Bulletin
Number 5043

LAND-ROVER

BRAKES

FRACTURE OF REAR BRAKE PIPE

Fig. 1. Shield for rear brake pipe.

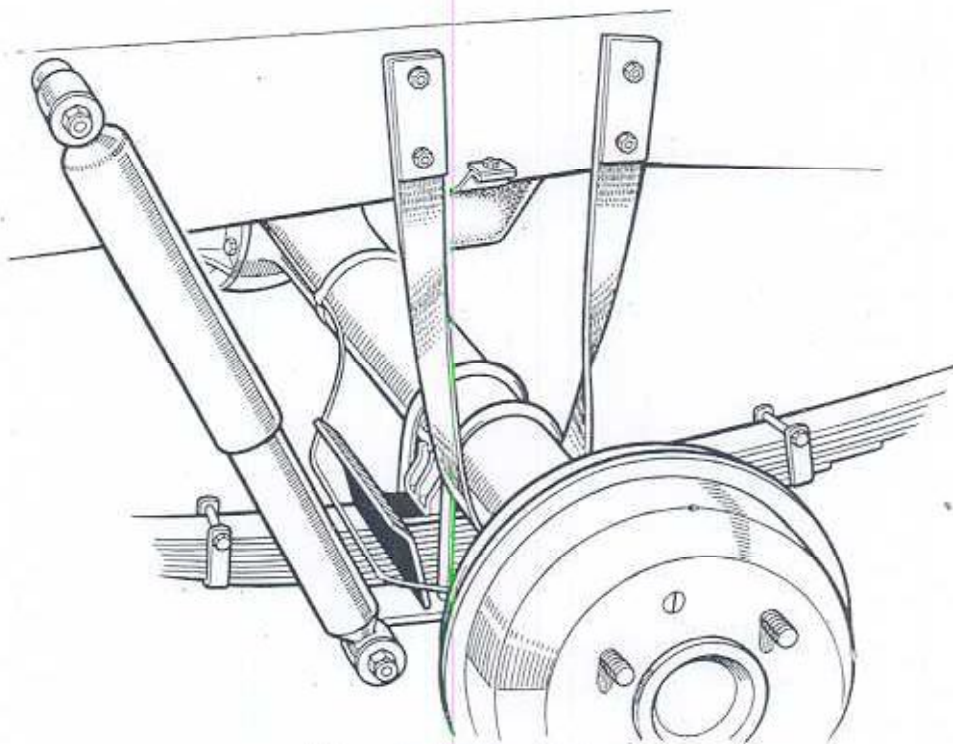
Under normal conditions the flexible check strap is slack; movement of the rear axle may allow the strap to chafe on the brake pipe, ultimately causing a fracture and consequent brake failure.

Renew the brake pipe and fit a suitable shield between the check strap and brake pipe on each side of the vehicle (see below for details).

Suitable shields (illustrated in position at Fig. 1) are obtainable free of charge from our Spares Department, the part numbers being L.H. 232089 and R.H. 232088.

Fig. 2. Details of R.H. brake pipe shield.

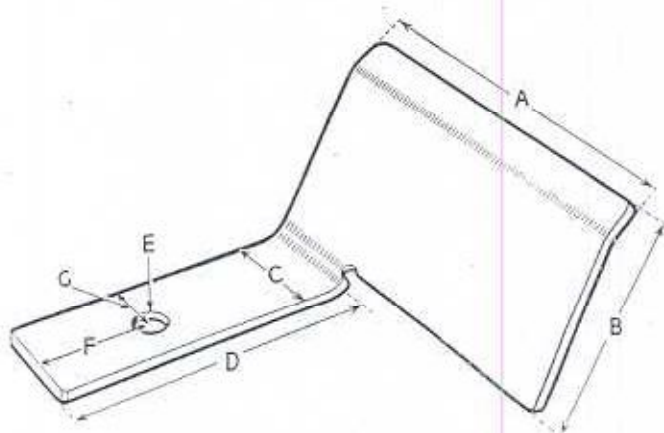
Alternatively the shields may be made locally from the dimensions given at Fig. 2.

- A — 5 in. (127 mm.)
- B — 3 in. (76 mm.)
- C — 1 $\frac{7}{8}$ in. (44,5 mm.)
- D — 4 $\frac{1}{2}$ in. (104 mm.)
- E — $\frac{1}{2}$ in. (13 mm.) hole.
- F — 2 in. (51 mm.)
- G — $\frac{1}{8}$ in. (22,25 mm.)

Each shield should be fitted between the rear axle casing and the road spring, with the hole located on the spring dowel; the protecting flange should be to the front between the check strap and the pipe. Ensure that there is ample clearance between the shield and pipe or preferably secure the pipe as described below.

Vehicles produced in future will be equipped with shields on assembly. In addition, each brake pipe will be secured to the shield by means of a clip Part No. 56666, rubber bush Part No. 06860 and drive screw Part No. 72626.
